CITY OF ALBUQUERQUE

**RE: APS Montgomery Complex
3315 Louisiana Blvd NE
Drainage Report and Grading Plan
Engineer's Stamp Date: 4/19/17
Hydrology File: G18D048**

**ALBUQUERQUE PUBLIC SCHOOLS
MONTGOMERY COMPLEX
DRAINAGE REPORT**

C102R
OVERALL GRADING & DRAINAGE PLAN

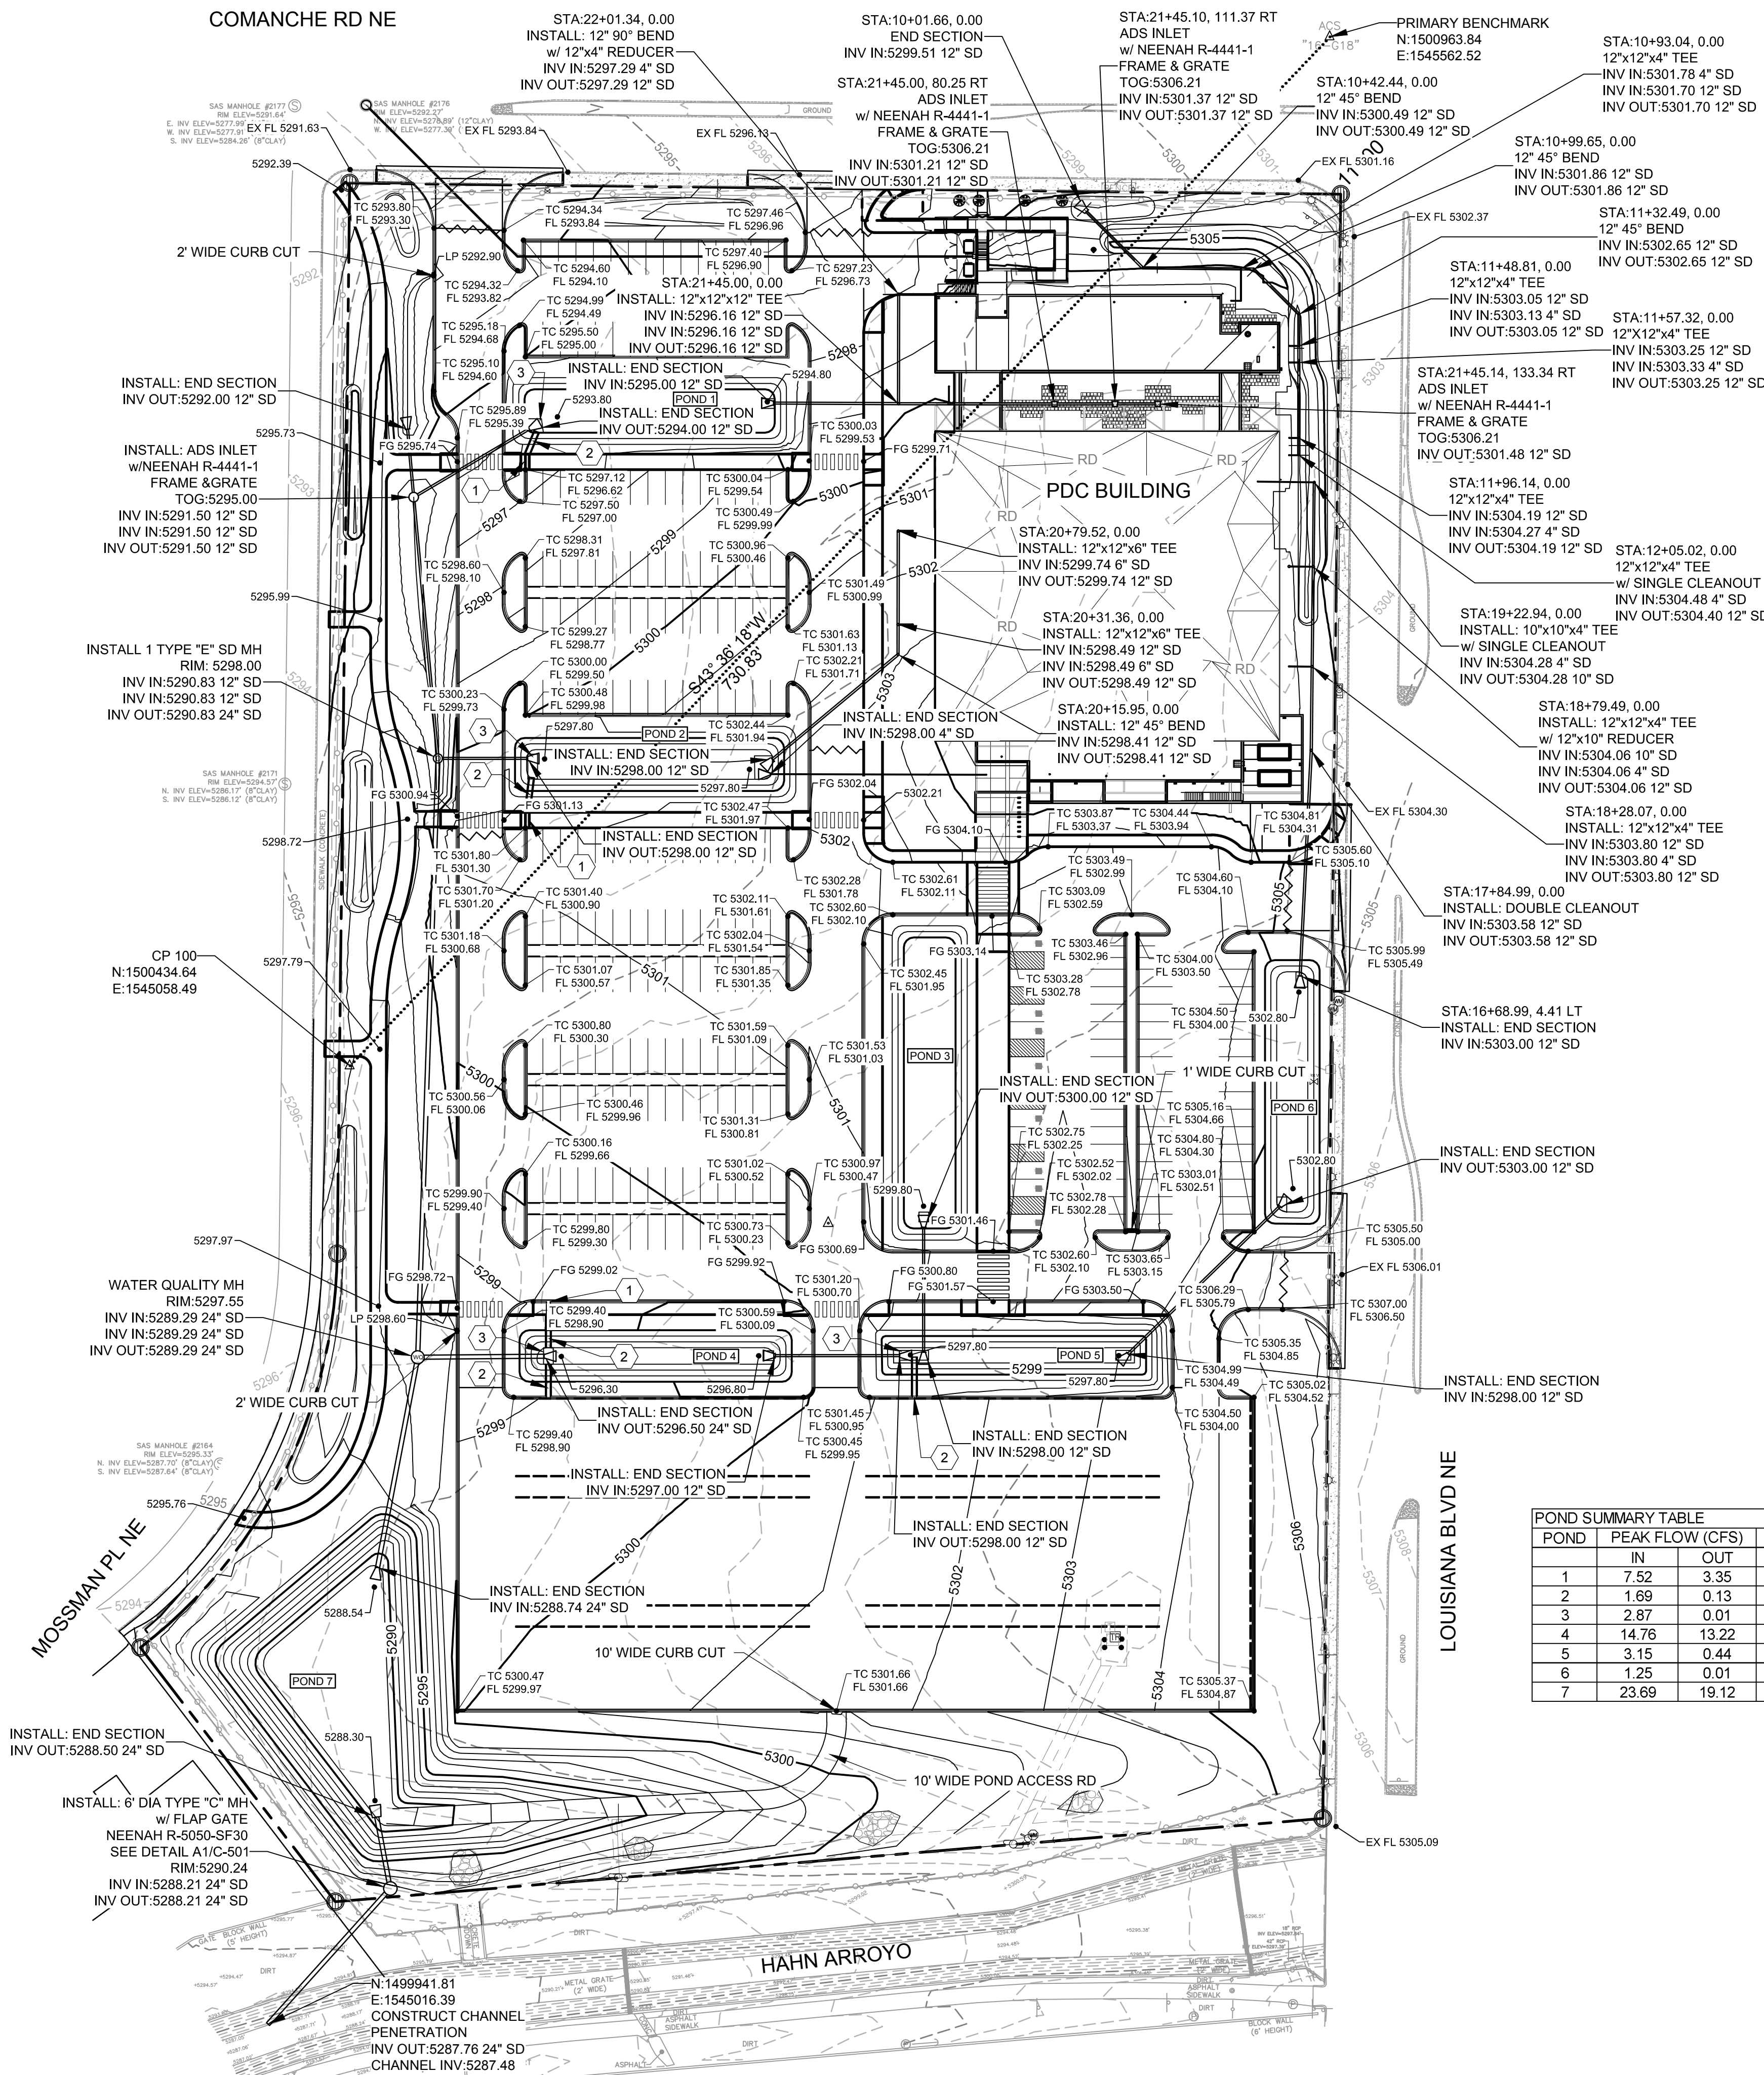
1. Provide finished floor elevation for the PDC building. Assuming the PDC building footprint is outside the Zone AO on Comanche, state so in the report (section 1.3).

2. Pond 7. Provide inlet protection on the outfall to prevent accidental entry. Also include a water quality feature to prevent sediment from washing into South Hahn.

3. Pond 4. Provide inlet protection on the outfall end section to prevent accidental entry.
4. It is unclear how the storm water quality volume is being retained. The report references use of each ponds' dead storage, however the outlet culverts are all within 0.2ft of pond bottom. Provide dead storage volumes and account for allowable error in construction finished grades (likely +/- 0.2 feet).

7. The penetration into South Hahn may be performed under SO-19 or mini- work order. State how the work will be performed on the Grading Plan. If using SO-19, include standard SO-19 notes. Prior to beginning work, notify Jason Rodriguez with Municipal Development to coordinate an inspection schedule (jtrodriguez@cabq.gov).
